MEMORANDUM

To: Development Review Board
From: Ken Lerner 
Date: June 7, 2011
RE: 09-181CA/CU 21 Ledge Road/ Amendment

Request: Addition to single family house, including 2 car garage, additional drive/parking area and an accessory apartment; removal of shed. **Amendments to ZP#09-181CA. Revised site changes: delete landscaped area & 2 maples, reduce number of arborvitae, add retaining wall, and expand driveway/parking. Reduce addition and size of deck. Change windows.**

SWALE ON EAST SIDE OF WALL TO DIRECT STORM WATER RUN OFF

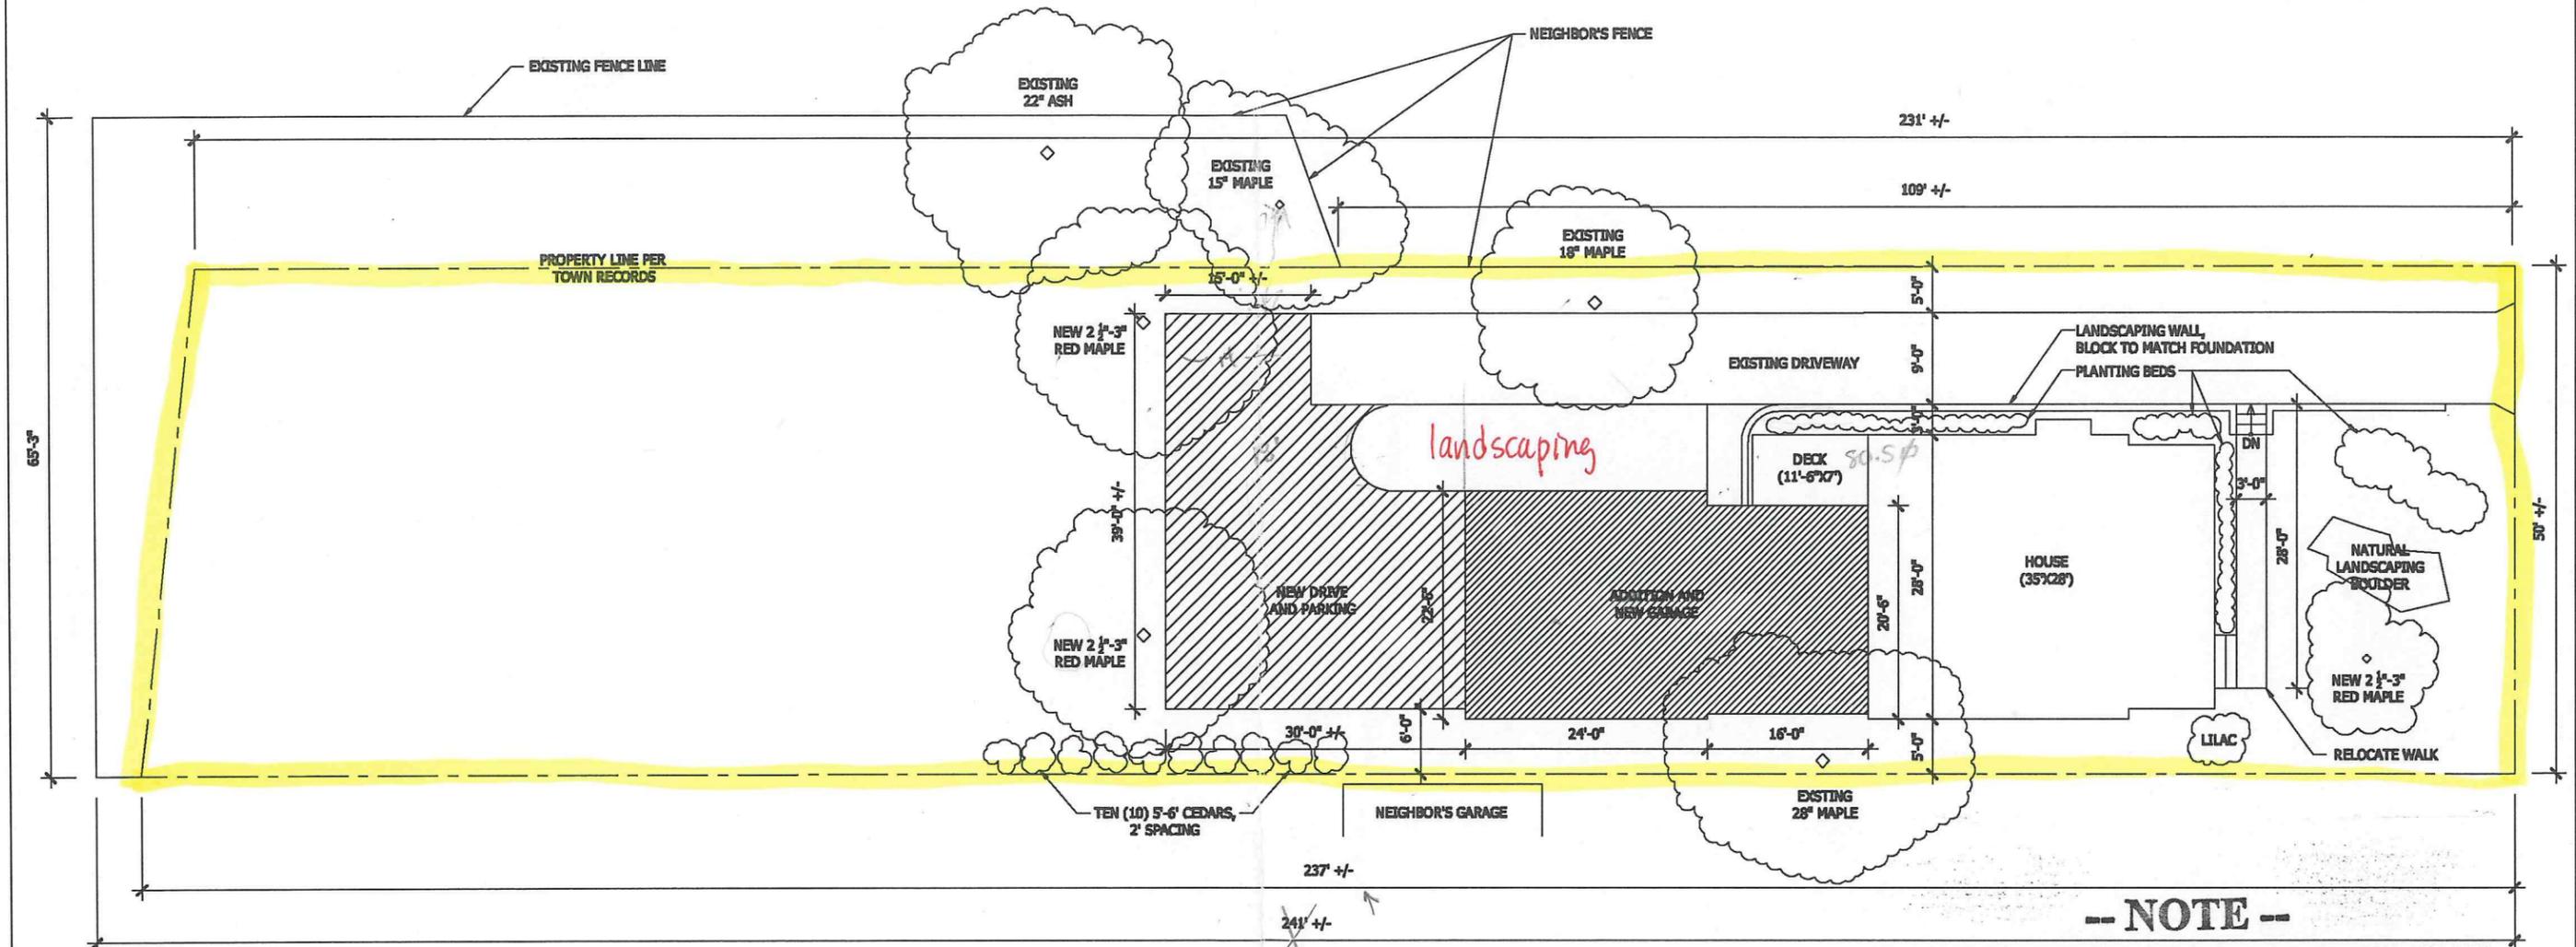
A new retaining wall at the east side of the large rear parking area is now proposed in addition to the previous retaining wall. It is 30 feet long and up to 3 ft. high. A sketch has been provided (not to scale), which has been reviewed by the City Engineer. There were no issues by the City Engineer as to this wall.

PROPOSED SITE PLAN

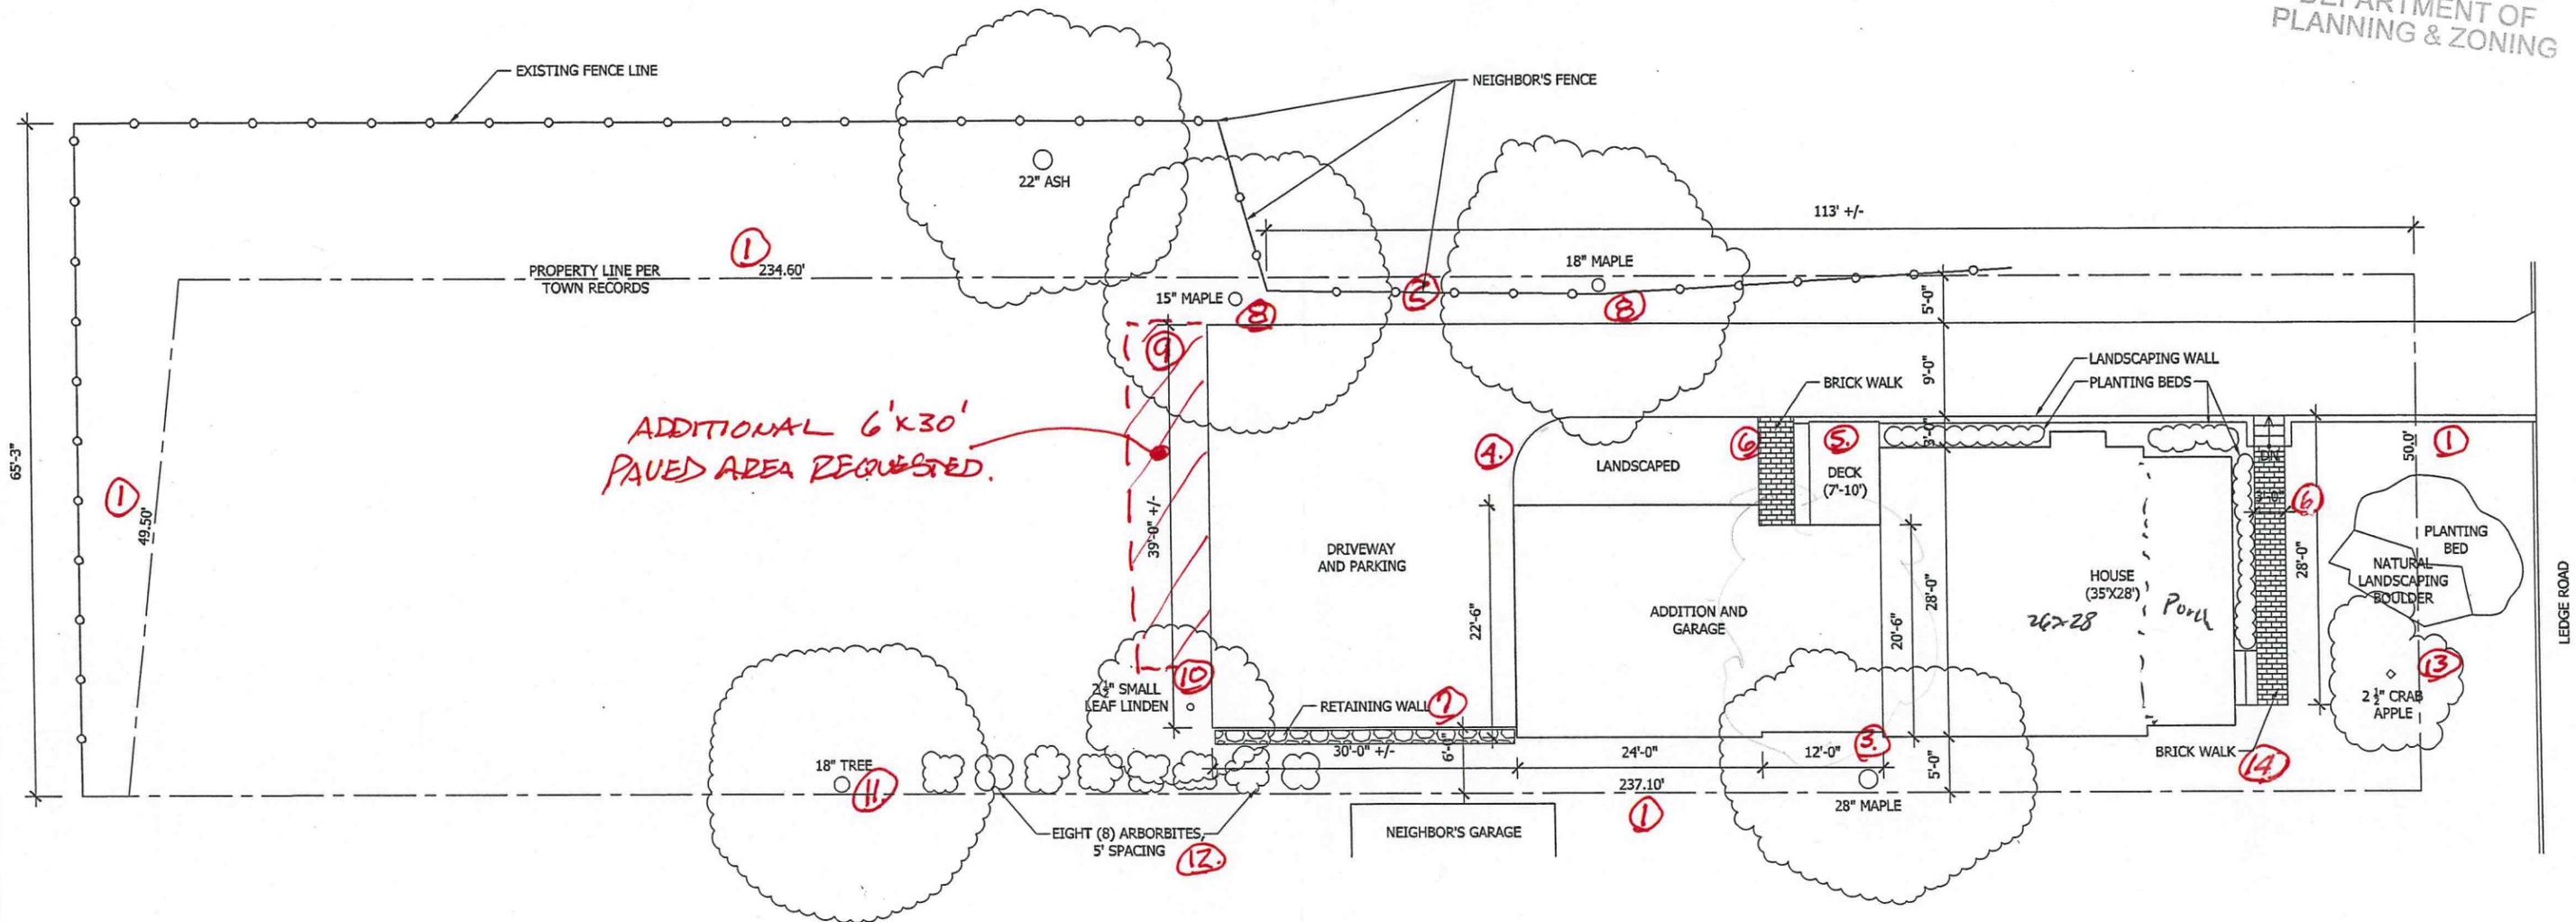
Information as to the edge outlining this peninsula is not specified.

In order to mitigate the original approved 1,170 sq. ft. (30' x 39') paved parking area, Condition # 7 was approved with the resulting site plan providing for a landscaped peninsula separating the driveway and parking area. The current proposal, with a larger parking area, now approximately 1,410 sf ([38' x 39'] – [6x9]), greatly reduces this landscaping buffer while increasing the paving.

The increased paving according to the applicant will help the circulation, but with the loss of this greenspace that helped break up the large amount of paving. The applicant has submitted a site plan that illustrates the reduced peninsula to reflect the DAB compromise (the applicant originally proposed to entirely eliminate the peninsula). Six parking spaces are proposed, with four in the rear parking area and two in a garage. This is more than the four spaces required. As the project is a

1. Inclusion of a minimum 2- 3 ft. deep landscaped peninsula, and allowing additional paving to the extent of the added peninsula.

NORTH ELEVATION - RECORD DRAWING

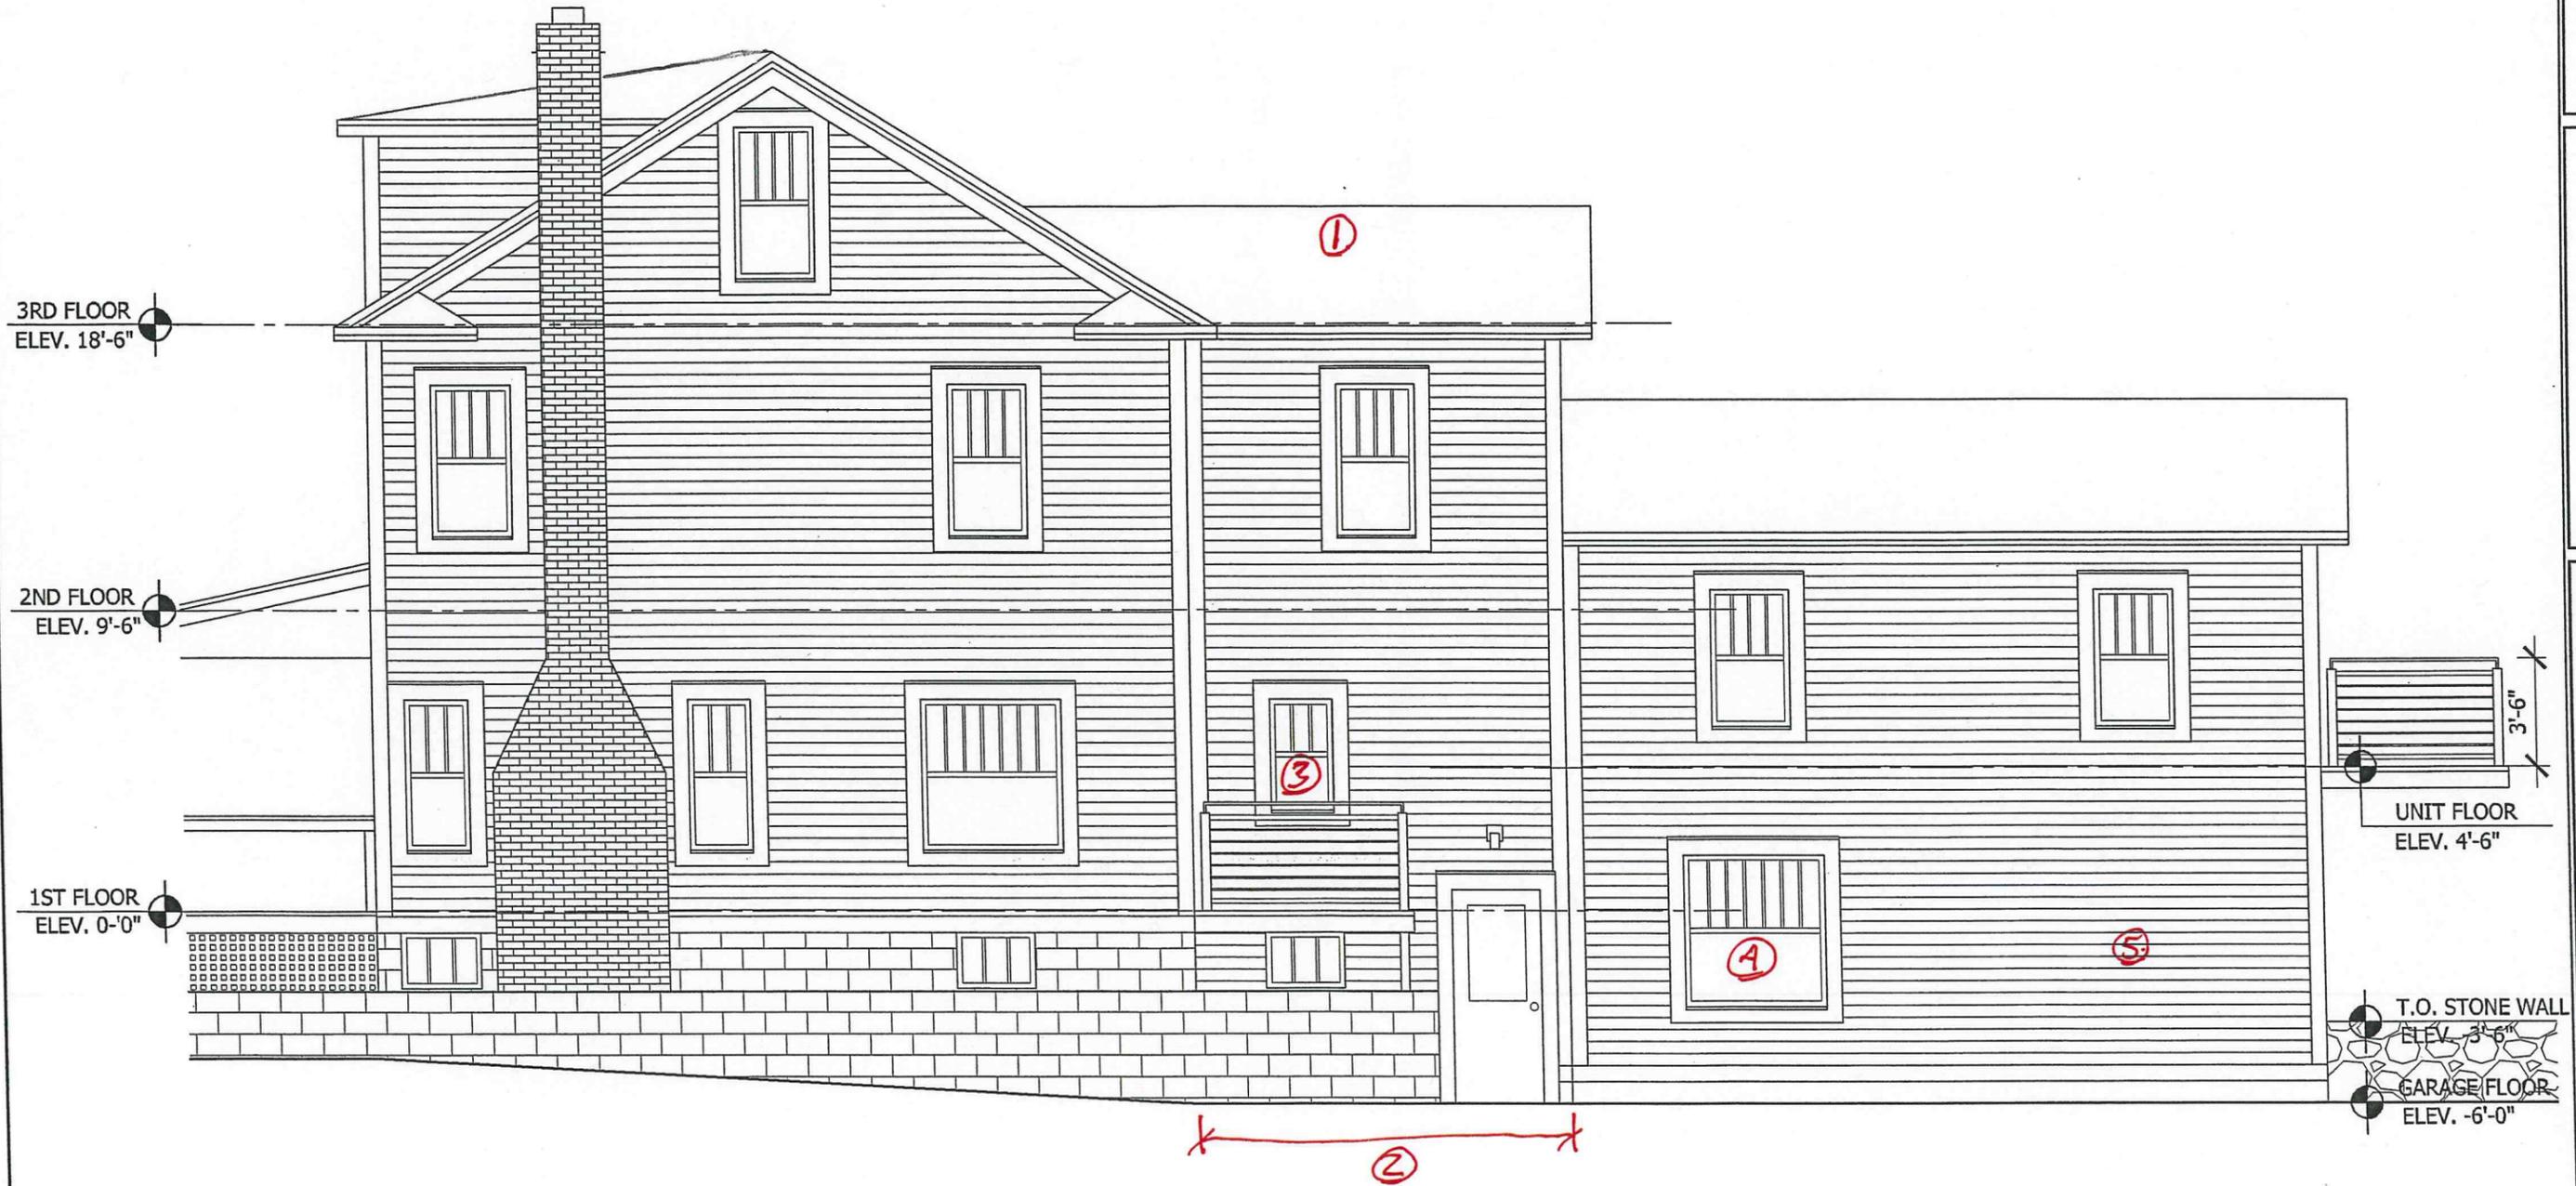
The electric meter and connection has been added to the north elevation. What appear to be vents are illustrated on the east elevation near the roofline; the other two elements may be dryer vents. These should be labeled on the elevations. No other utility meters are depicted and should be illustrated on revised elevations.

WEST ELEVATION - RECORD DRAWING

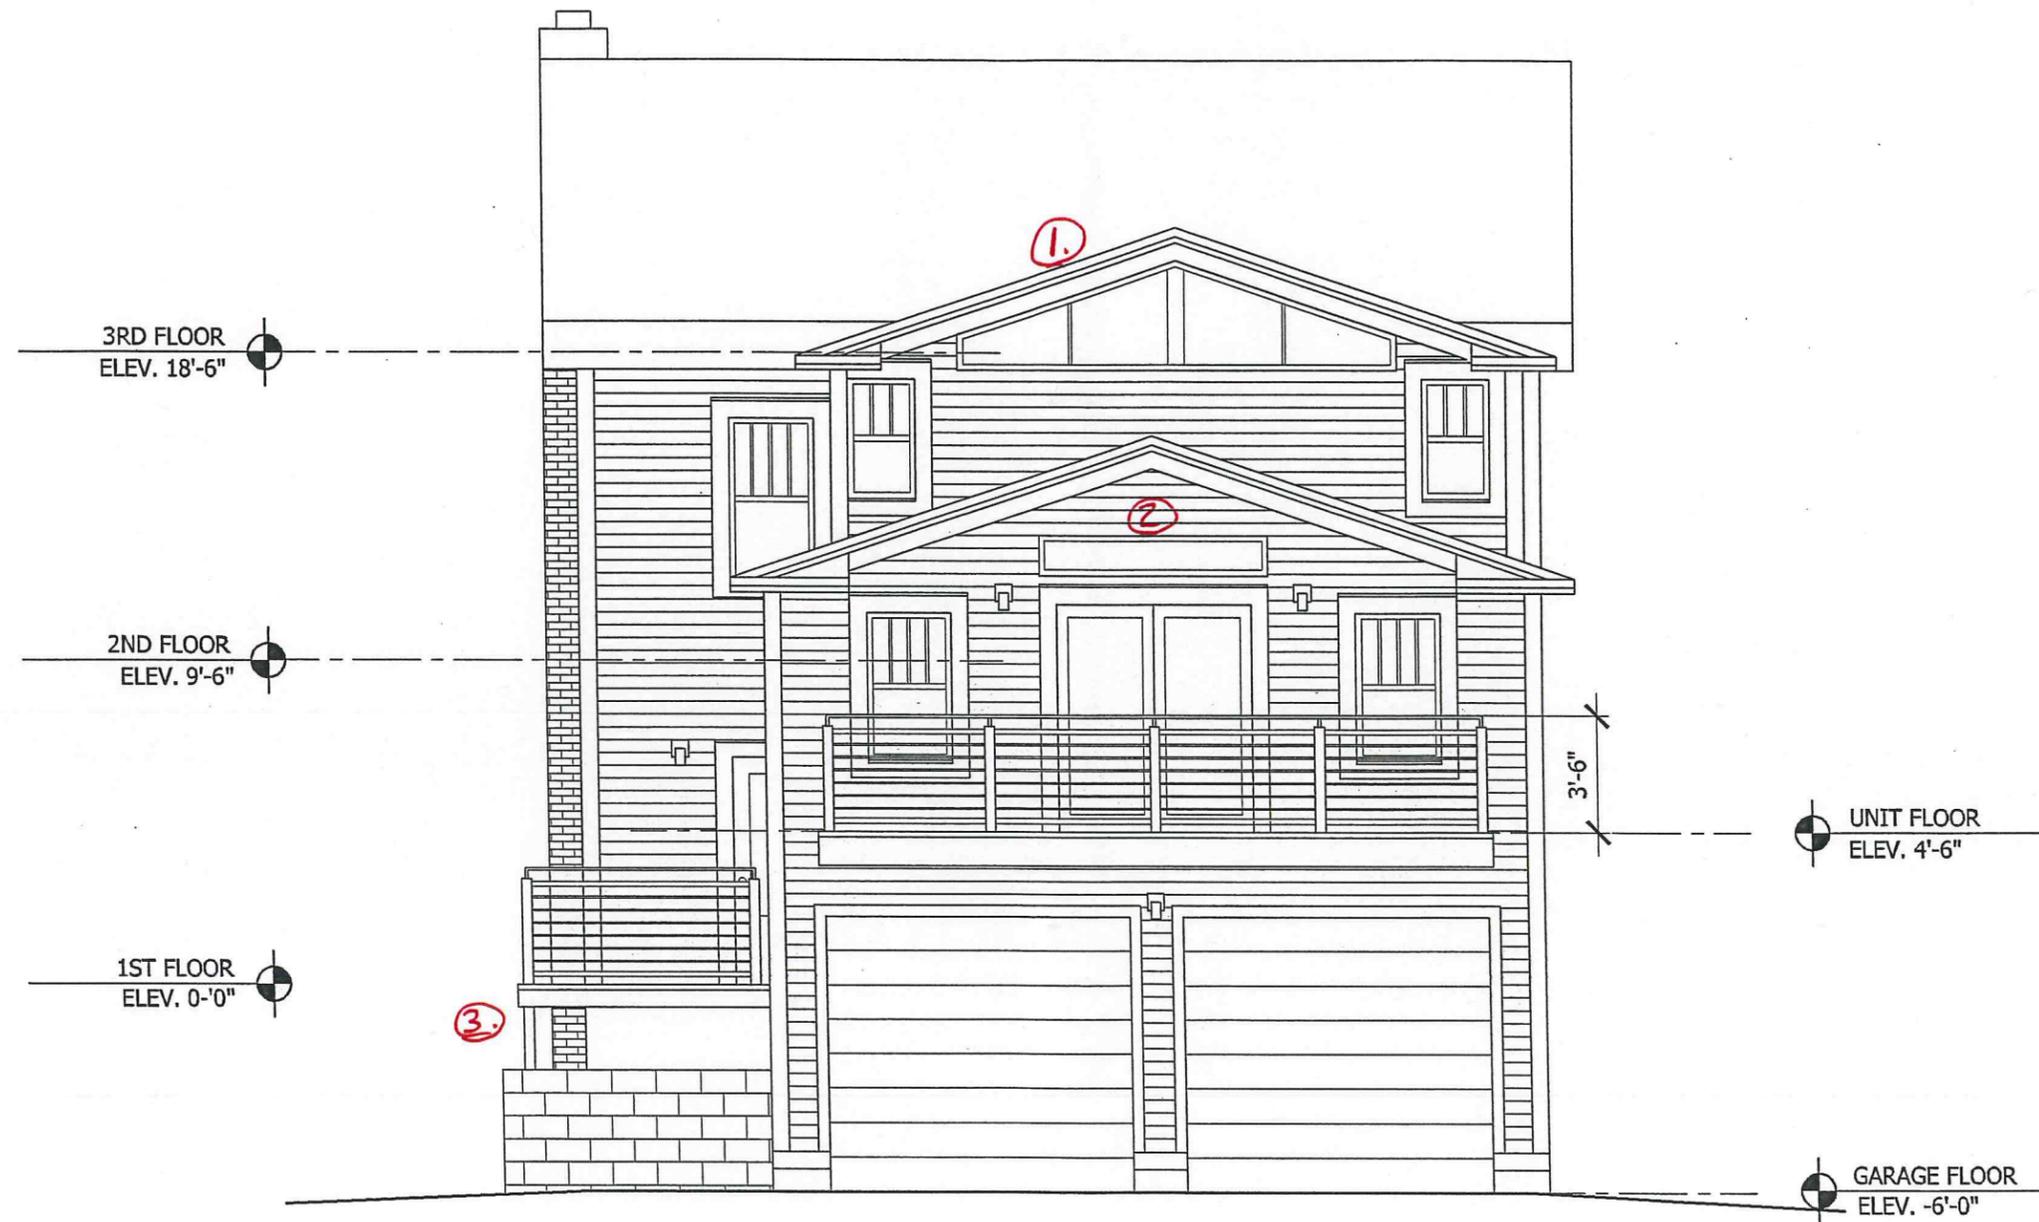
The building elevations have been revised to include windows that differ from the previous proposal. However, these changes are acceptable. Affirmative finding.
